# 1968 Corvette: Service News: Corvette Folding Top Compartment Lid to Folding Top Interference (SN-68-20)

**Subject:** Corvette Folding Top Compartment Lid to Folding Top Interference (SN-68-20)

**Model and Year:** 1968 Corvette

**Date:** April 1968, Volume 40, Issue Number 4

**Fig. 12—Remove  $\frac{1}{8}$ " From Lid Stops**

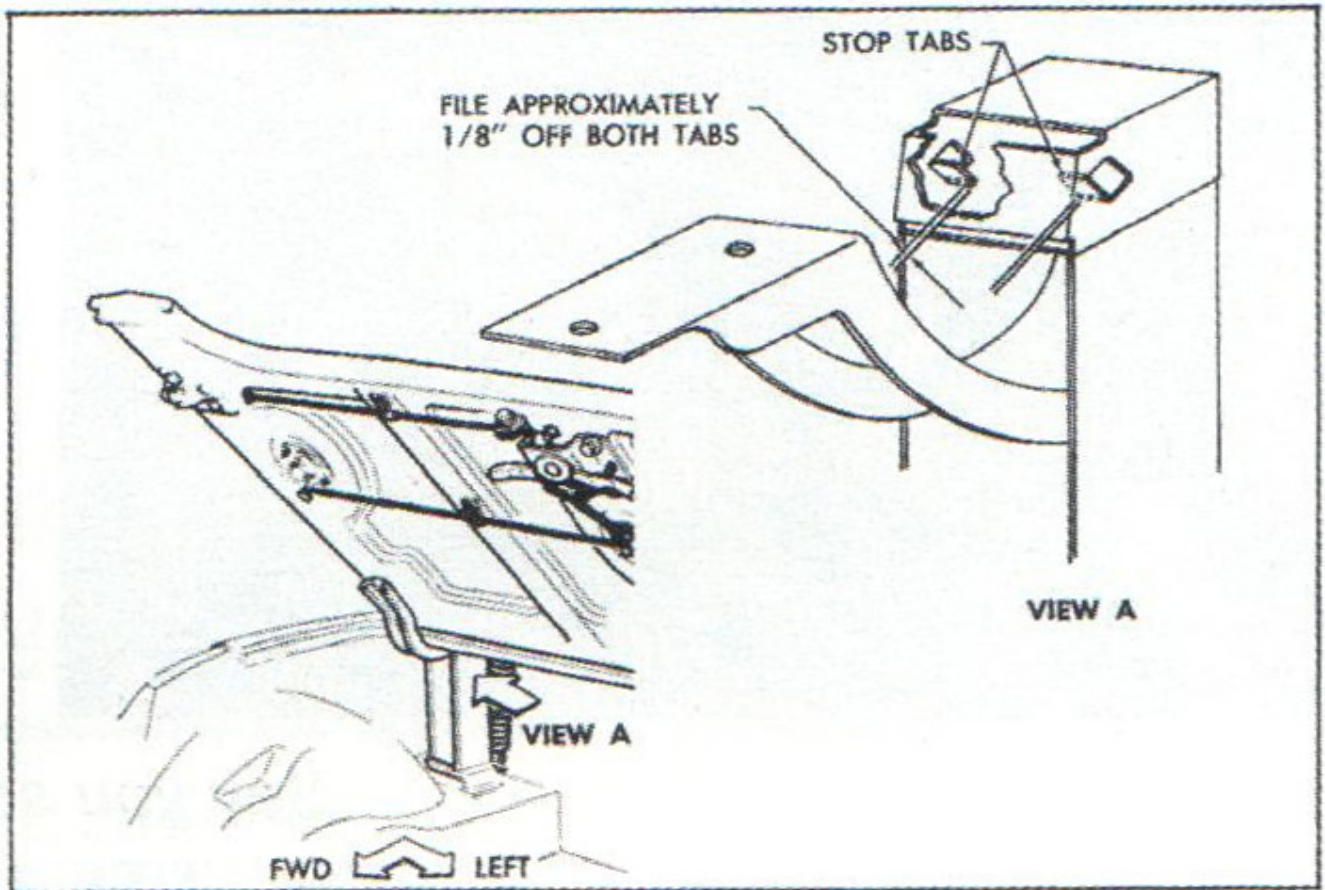
It has been found that the rear compartment lid on some 1968 Corvettes interferes with the convertible top when the top is being raised or lowered. This interference is easily eliminated by filing approximately 1/8" off the existing hinge stops (right and left side). Removing 1/8" from the hinge stops, as shown in Figure 12, allows the rear compartment lid to raise farther thus eliminating the interference condition. The stops referred to are simply tabs that has been punched out of the hinge support members.
